**THE CITY OF NEW YORK  
DEPARTMENT OF DESIGN AND CONSTRUCTION  
DIVISION OF INFRASTRUCTURE**

**SCHEDULE A  
ADDENDA NOS. 1 TO 4**

**PROJECT ID: HEDA001**

**FOR THE CONSTRUCTION OF ACCELERATED WATER MAIN  
REPLACEMENT AND SEWER REHABILITATION AND REPLACEMENT**

**STEEL MAIN OR SERVICE (DISTRIBUTION)**

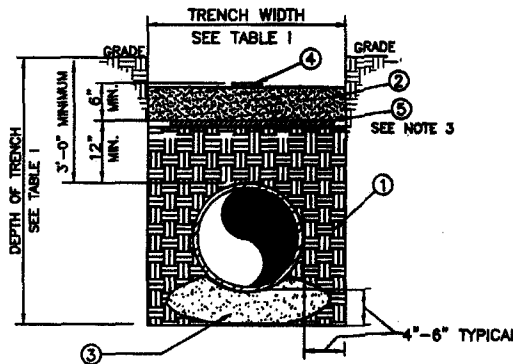
R. GROGAN	7/21/08	0
M. BALDOVIN	2/02/08	1
REVISED TRENCH WIDTH FOR 4" THRU 12" MAINS IN TABLE 1 REMOVED REQUIREMENT FOR SANDBAGS FOR STEEL DISTRIBUTION MAIN.		
RAJ.	2/11/08	
M. BALDOVIN	4/04/08	2
ADDED REQUIREMENTS OF SAND BAGS FOR STEEL DISTRIBUTION MAIN.		
RAJ.	4/4/08	
M. BALDOVIN	3/12/08	3
REVISED TRENCH WIDTH OF 18" AND GREATER SIZE MAINS IN TABLE 1.		
P.L.S.	1/28/08	
M. BALDOVIN	04/29/13	4
REVISED TITLE REVISED DRAWING IN ITS ENTIRETY.		
HT	04/24/13
